Access Compliance Report Public Rights-of-Way (Curb Ramps)

Main Street: MELVIN_WAY Cross Street: DEAN_ST Location: N

ADA ID: RPRK220103151606 Ramp Type: Type 1 - Perpendicular Diagonal Initial Pass/Fail: Pass Overall Compliance: No Severity Score: 2

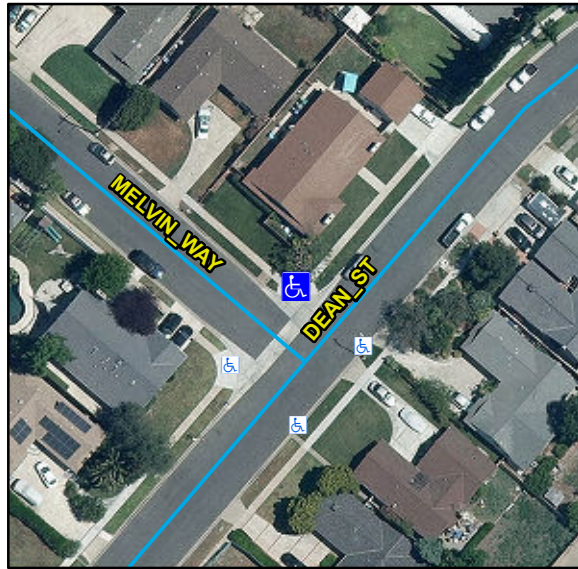
R304.2.2, R304.2.1, STD 1115

Remove & Replace Curb Ramp With Two New Directional Ramps or Equivalent.
